KPA500 KIT ASSEMBLY MANUAL ERRATA

Rev. F6-3, December 23, 2016

E740149E

Figure 34. Connecting the 270V Wire to the PA/LPF Module.

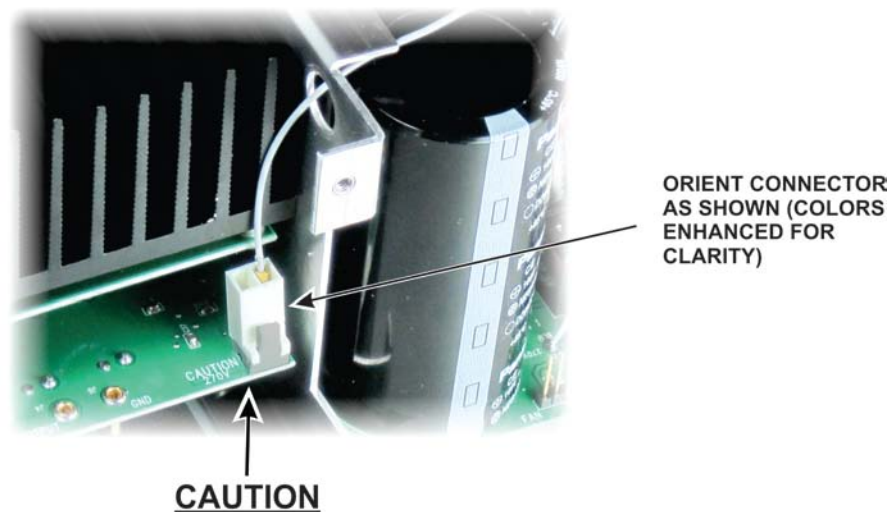
1. Page 25, replace the last check box step and Figure 34 with the following:

Connect the 270V wire from the power supply module to the PA/LPF module as shown in Figure 34. **Support the pc board so it does not flex while mating the connector.** This is the connector you routed through the hole in the Z-bracket earlier.

CAUTION
SUPPORT THE BOARD FROM BELOW WITH YOUR FINGERS
WHILE ATTACHING THE CONNECTOR SO THE BOARD CANNOT FLEX.
ALLOWING THE BOARD TO FLEX MAY BREAK COMPONENTS ON THE BOARD.
